TO: Winnebago Industries, Inc. Dealers

SUBJECT: Campaign #105 – Exterior Drawer Secondary Catch

INSTRUCTIONS TO PERFORM CAMPAIGN 105

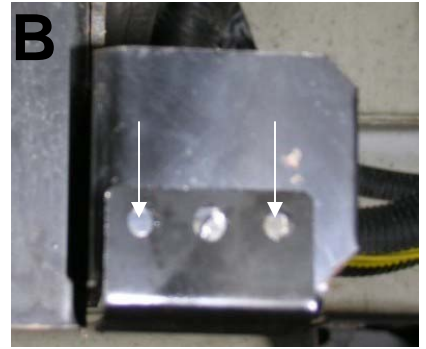
The two slideout drawer latches use vise action latches that swivel on an offset pawl. The pawl traps a metal support between the pawl and the door, allowing secure confinement of the drawer. This recall procedure will be to add a return flange to the rear metal support and to add a secondary catch that will engage the return flange when opening the slideout drawer. This will limit travel of the compartment in the event the primary latches are not engaged.

1. Turn the outside knobs and open the slideout storage drawer. Inspect the areas of intended work to assure that nothing has been damaged.
2. Clean the surface of the metal support.
3. Remove the backing of the adhesive tape on the return flange.
4. Place the return flange (provided) on the metal support, positioning it toward the rear edge as shown in Photo A.

NOTE: It is important to offset the installation of the return flange in order to avoid interference with the operation of the slideout drawer latch/pawl.

5. Drill (2) holes and install rivets in locations shown on Photo B.
6. Clean the interior of the drawer area where the secondary catch will be installed.
7. Holding the secondary catch (provided), position the catch allowing it to pass the return flange while closing the drawer, but catching the return flange when opening the drawer. Remove the backing to the two-sided adhesive and place in position. Shown in Photo C.

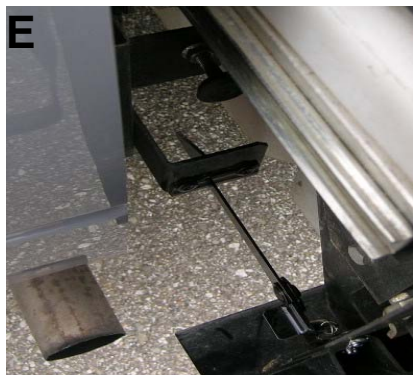
8. With the adhesive tape holding the secondary catch in place, drill (2) rivet holes using a 3/16 drill bit and install the rivets (provided). Shown in Photo D.

| NOTICE |
| Care must be taken when drilling holes to ensure you do not pass through metal and damage the exterior drawer skin. |

9. Check your installed secondary catch and return flange to ensure proper operation when opening and closing the slideout drawer. Shown in Photo E.
